PZ&B Staff Combination Memorandum: Landmarks Preservation Commission and Town Council

SUBJECT: COA-24-0001 (ZON-24-0004) 126 S OCEAN BLVD (COMBO)

MEETING: JUNE 21, 2024, LPC
JULY 10, 2024, TC

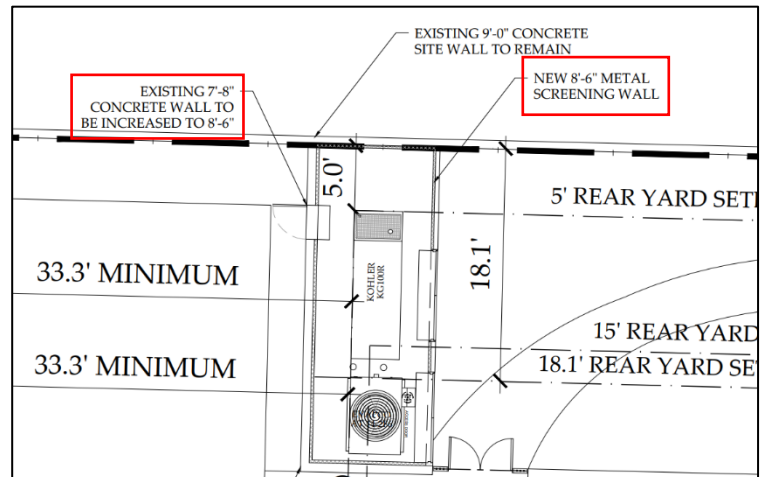
The application as proposed requires three (3) variances for construction. As the diagram below illustrates, **Variances 1 and 2** seek a reduced rear setback of 5' in lieu of the required 15' per Section 134-793(a)(9) and a reduced street-side yard setback of 33.3' in lieu of the required 35' per Section 134-793(a)(5).

Code Section	Required	Proposed	Variance
Variance 1: Sec. 134-793(a)(9)	15' Rear Setback	5' Rear Setback	10'
Variance 2: Sec. 134-793(a)(5)	35' Street Side Yard Setback	33.3' Street Side Yard Setback	1.7'

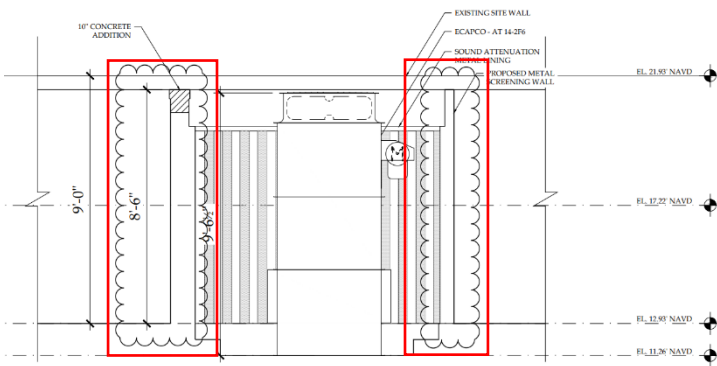
As the diagram below illustrates, **Variance 3** occurs because a higher enclosure wall height is needed to screen the replacement cooling tower and generator.

Code Section	Required	Proposed	Variance
Variance 3: Sec. 134-1667 Sec. 134-1669	7' – Max. Wall Height Side Yard 6' – Max. Wall Height Front/Street Side Yard	8.5' Site Wall Height	1.5' - Side Yard 2.5' – Front/Street Side Yard
